From: Anthony Hulse <AHulse@PuyallupWA.gov>
Sent: Thursday, August 17, 2023 3:48 PM
To: Craig Deaver; Ken Cook; Dawn Sinagra; Hans Hunger
Cc: Eric Oehler; Roger Hebert; Bryan Roberts; Rachael N. Brown; Lance Hollingsworth
Subject: RE: Puyallup Duplex Fee in Lieu Request # PLSHP20220104 CES20069

Thank you for sending over those exhibits. The city has evaluated the options and exhibit 3 seems the most appropriate with a few revisions:

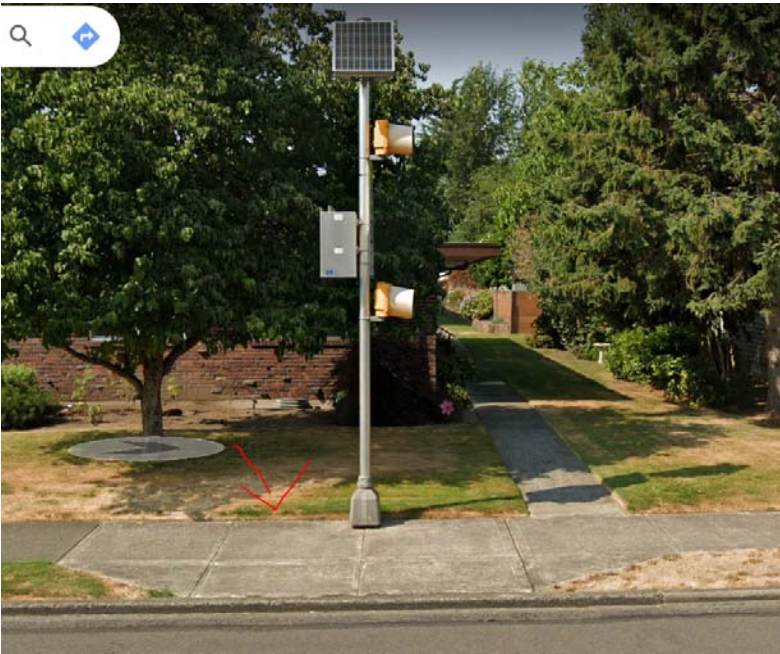
1. Shift the back of the sidewalk to abut the property line.
2. The proposed sidewalk must be ADA compliant. Due to the location of the hydrant, the sidewalk can be stopped just short of the western property line to avoid re-location. Additionally, the planter strip can be shortened to provide additional sidewalk width to provide a minimum 4' ADA pathway section along the power pole. See example below:
